## **R99DK**

Blue Bird Body Company has determined that a defect which relates to motor vehicle safety exists in certain 1999 and 2000 year model Blue Bird TC/2000 school and transit front engine buses and Commercial Series front engine buses equipped with optional Hendrickson Parasteer front air suspension. Blue Bird is conducting a recall to correct this defect.

**RECALL R99DK  
HENDRICKSON PARASTEER  
AXLE DAMPER INSTALLATION INSTRUCTIONS**

Figure 1

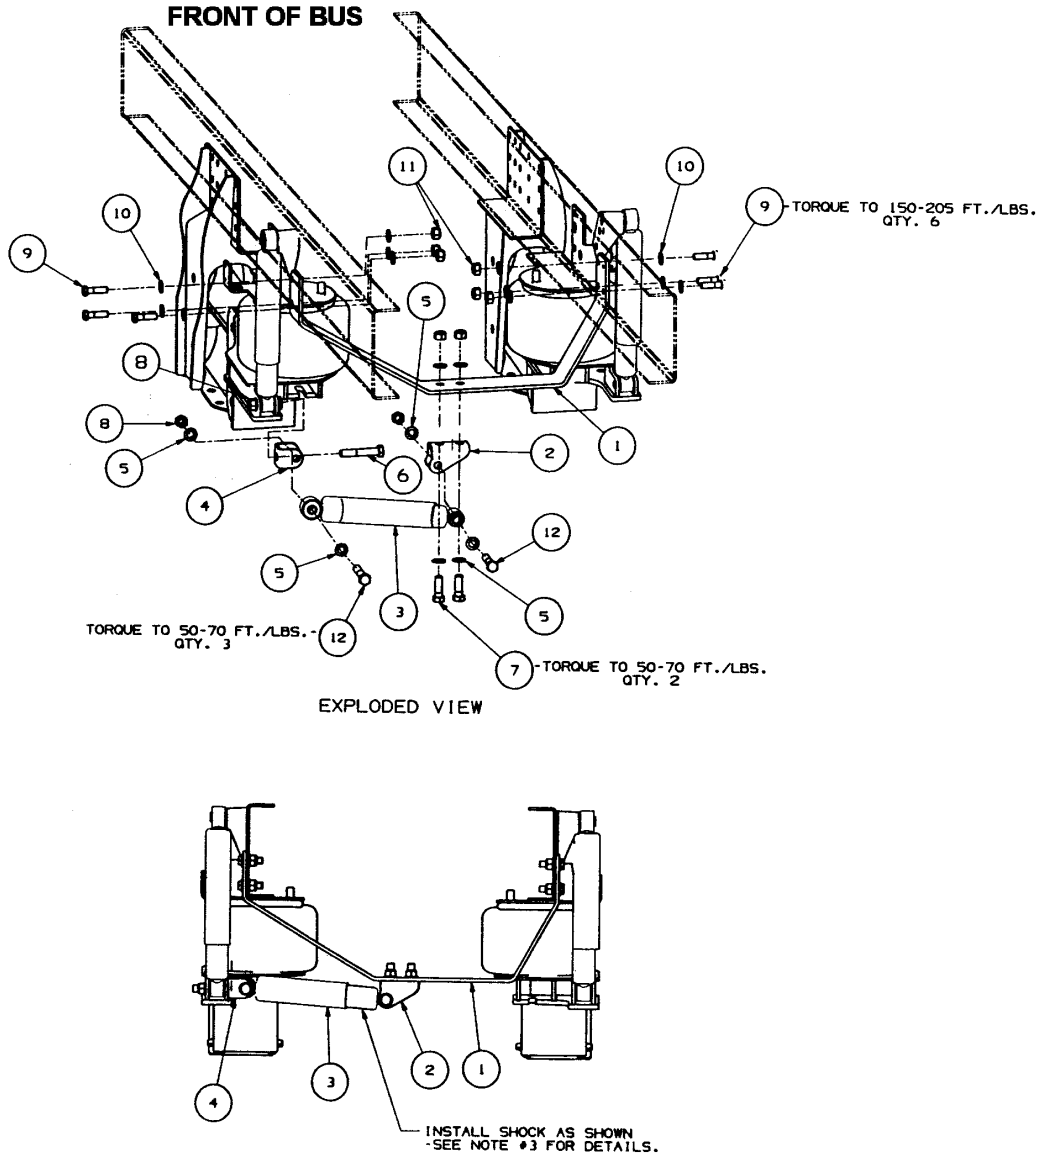
The defect involves the potential occurrence of a shimmy in the front end when the bus hits a bump or pothole. An axle damper must be installed to eliminate the potential for shimmy in the front end.

4. Detach the ABS valves at each side of the frame rails.
5. Position the crossmember (item 1) on the bus behind the front suspension air springs. See Figure 1. Use the upper front hole of the ABS valve at each side of the rail to position the crossmember on the frame rails. See Figure 2.

8. Install the cross member to the frame rails with six (6) 5/8" x 2 1/4 in bolts (item 9), twelve (12) 5/8" hardened washers (item 10) and six (6) 5/8" locknuts (item 11). See Figure 1. Torque fasteners to 150-205 ft. lbs.

1. Replace all used locknuts with new locknuts provided in kit.
2. Follow the recommended torque for fastening the hardware provided in the service kit.
3. Position stabilizer shock (item 3) with large end toward outside of bus as shown in illustration at bottom of Figure 1.
